## ONX-W09\_SectionA-A\_newholes.pdf

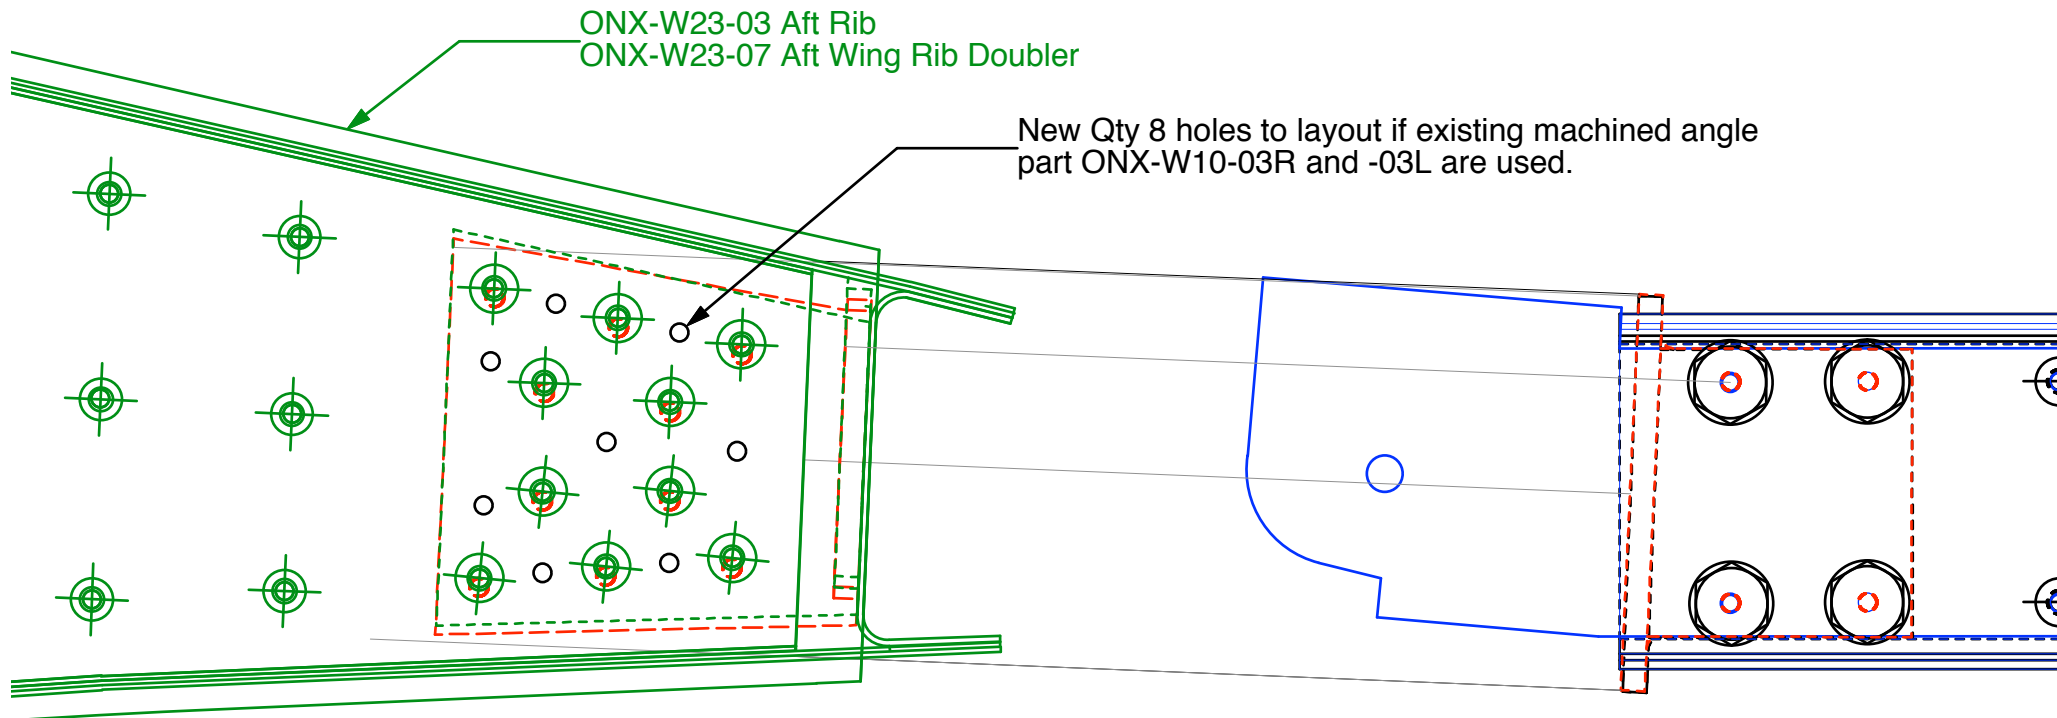
This detail shows the new hole layout to put through ONX-W23-03R/L, ONX-W23-07, and ONX-W10-03R/L to achieve correct alignment between joint rib and the rear spar. Qty 8 new hole layout is in black.

ONX-W09 Section A-A (Rib #6) in Green.  
ONX-W10-03R Part in Red  
Incorrect hole alignment shown with green holes not aligning with red holes.

ONX-W10-01R Assembly in Blue.  
ONX-W10-03R Part in Red  
This assembly is correct

Other option is to remake the ONX-W10-03R and -03L per the detail provided on print ONX-W10 and leave out the interfacing holes with the aft rib and aft rib doubler.
